August 17, 2012 (Revised September 20, 2012)

Subject: Southwestern Parkway Storage Basin
Minor Project Modification
IOAP Project No. L_OR_MF_105_M_13_B_A_0
DOJ Case No. 90-5-1-1-08254

2009 IOAP Project Description

Proposed Project Modification

Southwestern Parkway Storage Basin

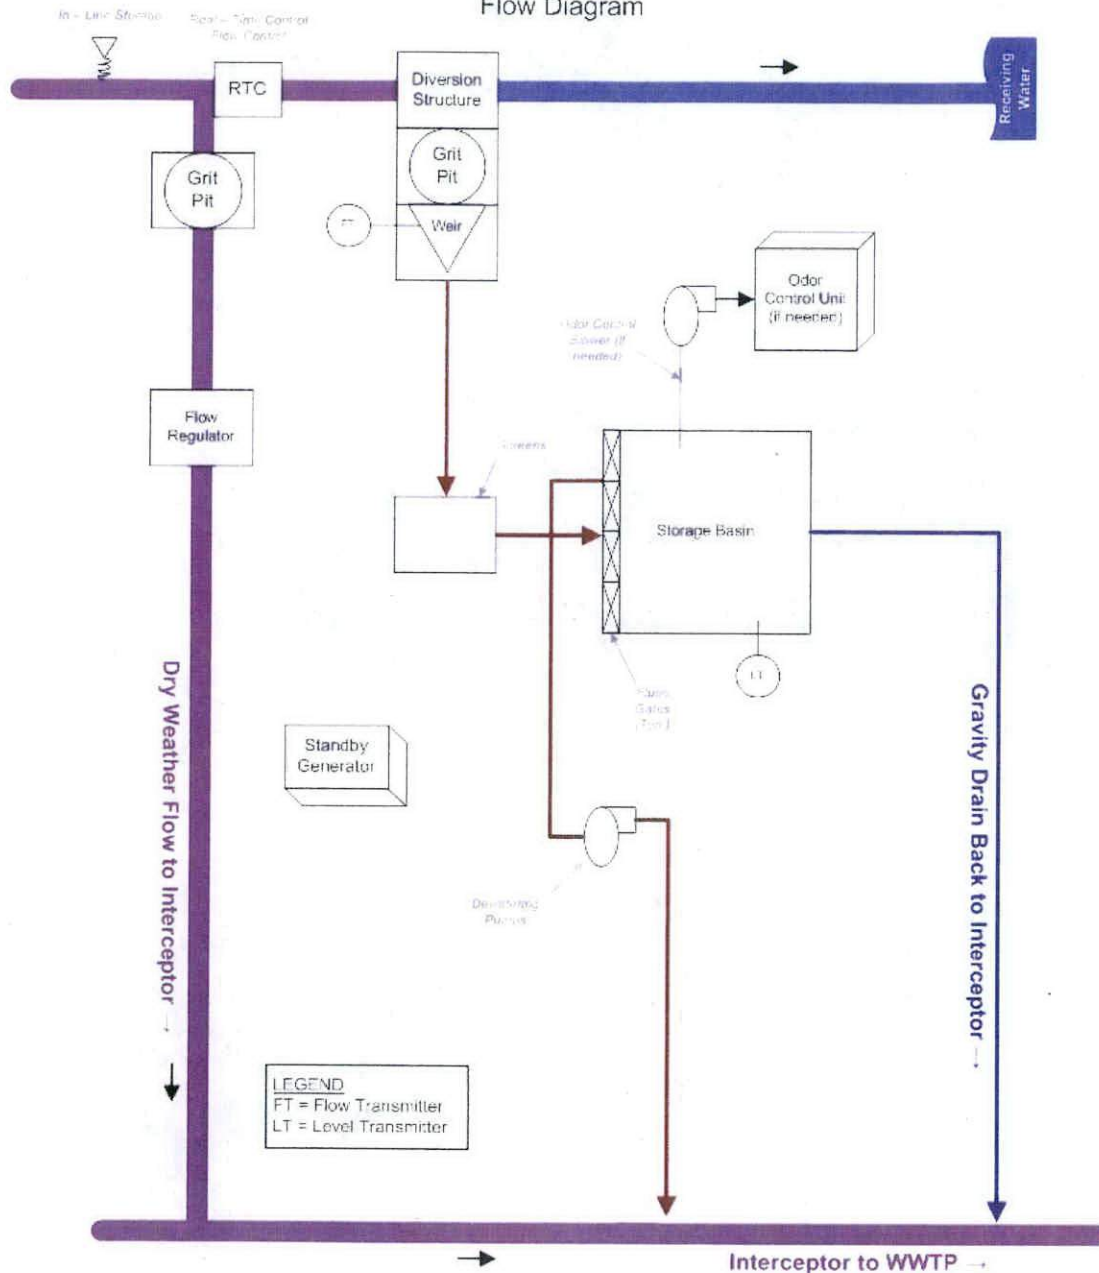
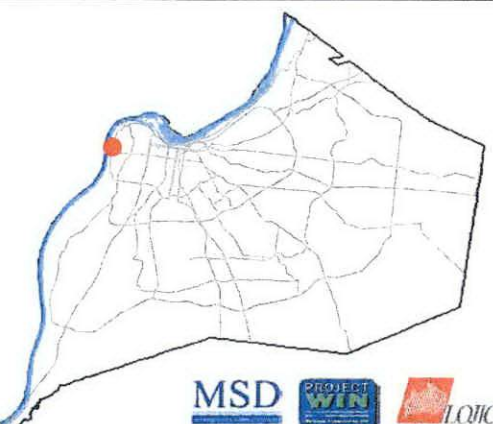
Due to the re-calibration of the sewer hydraulic model, the project modification includes the construction of 11.07 MG of offline storage along with the 8.8 MG of in-line storage at the two facilities described above with the project deadline remaining at December 31, 2018. The level of control is higher at zero overflows in a typical year based on a revised benefit/cost analysis.

Based on the results of the re-calibration, a level of control analysis was conducted on the Southwestern Parkway Storage Basin. The level of control with the basin sized at 11.07 MG is higher at zero overflows in a typical year. Therefore, MSD proposes to change the Southwestern Parkway Storage Basin solution from 5.08 MG to 11.07 MG. This solution also includes the construction of an in-line control structure on the overflow line to create an additional 8.8 MG of in-line storage. These improvements will maintain the same completion date of December 31, 2018, as the original solution.

Project Description: This project includes a 11.07 MG underground covered concrete basin for CSO104, 105, and 189 and in-line storage in the WO and the NWI for an additional 8.8 MG using adjustable gates to reduced overflows to zero overflows per typical year.
